# 15 Responses to Individual Comments

## 15.1 Federal Agencies

## FEDERAL AGENCIES THAT SUBMITTED COMMENTS ON THE DRAFT PEIR

**Figure 15.2-1**  
Flow Conditions at Diversion Dam  
under Various Operational Scenarios—  
pre- vs. post-DSOD Restrictions

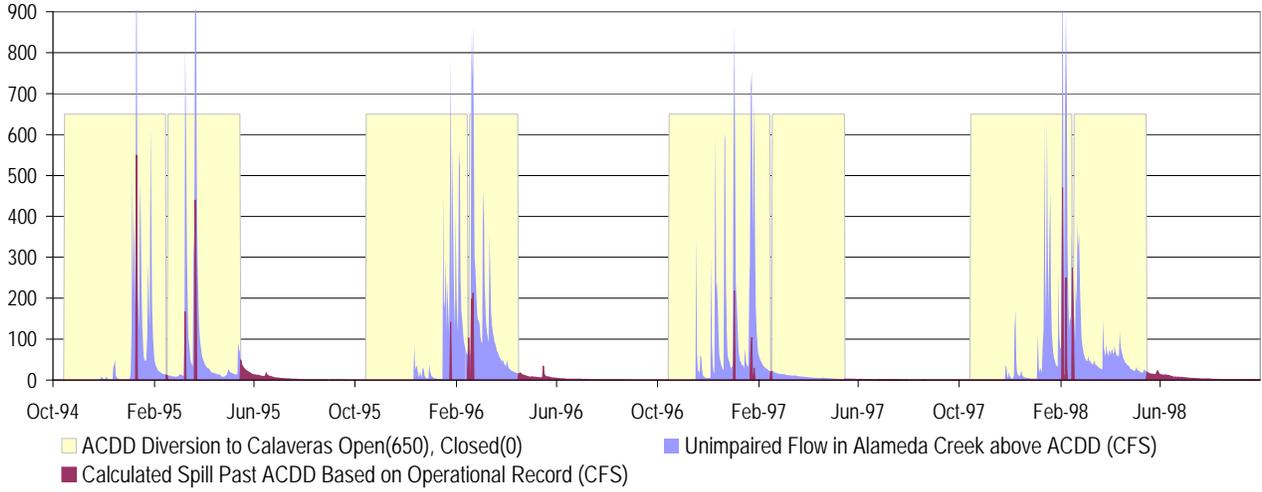
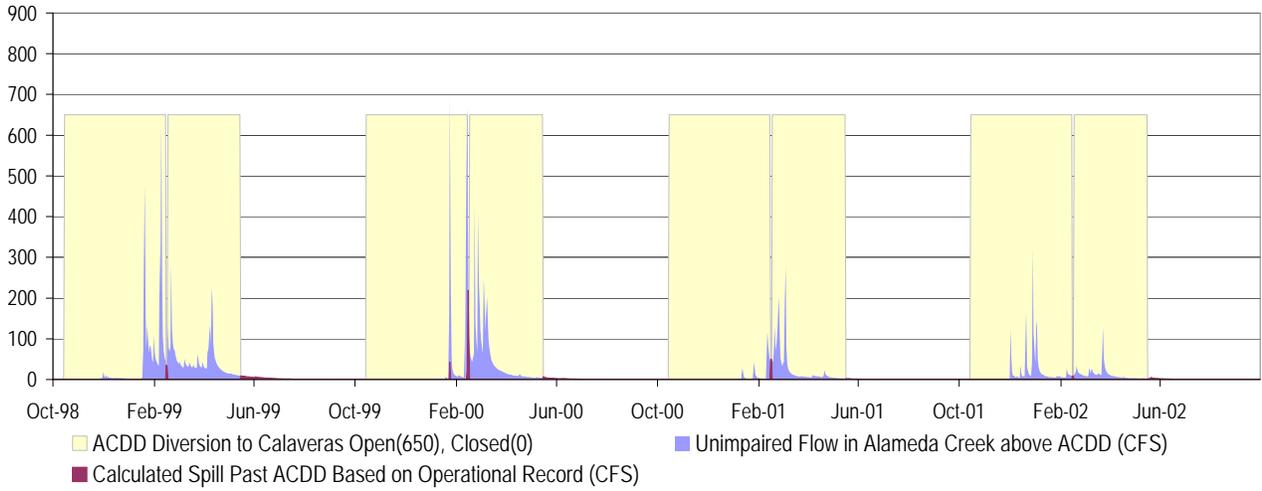
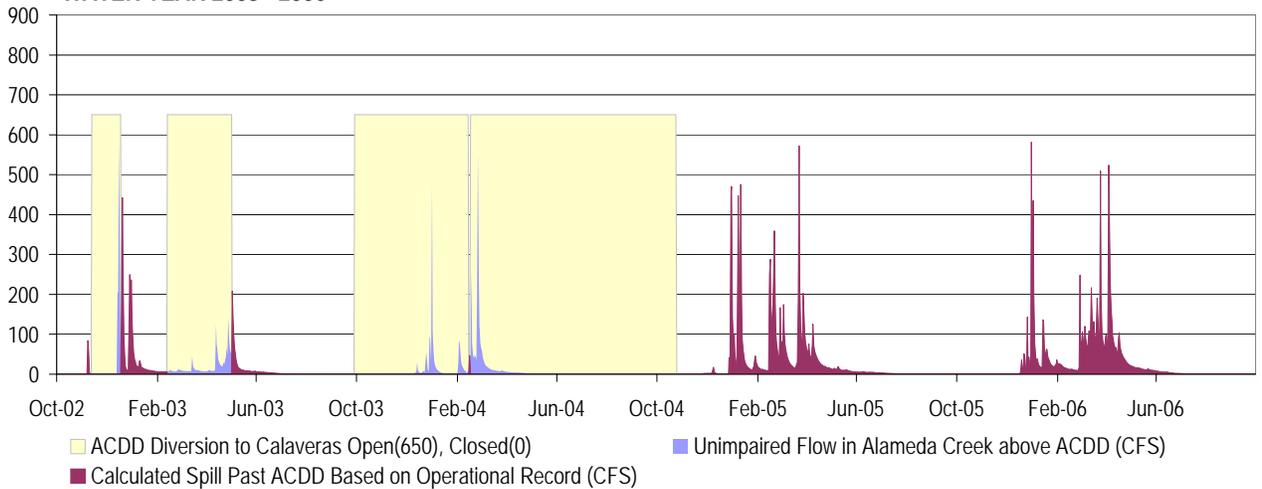
As noted by the commenter, these more frequent moderate flows occurring during the current operating condition have likely mobilized and transported sediment in Alameda Creek downstream of the diversion dam that would not have been mobilized by the lesser flows under the unrestricted pre-2002 condition. However, it should be noted that implementation of the DSOD restriction has not resulted in a cessation of all diversions; under the

**Figure 15.2-1** shows changes in flow conditions at the ACDD over the period of available gage record, incorporating operational variations that have occurred pre- and post-DSOD restrictions. The blue area of the figure represents inflow from upper Alameda Creek to the diversion dam; the maroon area represents the calculated flow below the diversion dam; and the yellow area indicates when the diversion gates were open to allow flows to be diverted to Calaveras Reservoir.

Since implementation of the DSOD restriction, the frequency and magnitude of diversions have become more variable, with reduced overall diversions to Calaveras Reservoir, particularly during wetter years; this has resulted in more flow in Alameda Creek downstream of the diversion dam as compared to the unrestricted pre-DSOD condition.
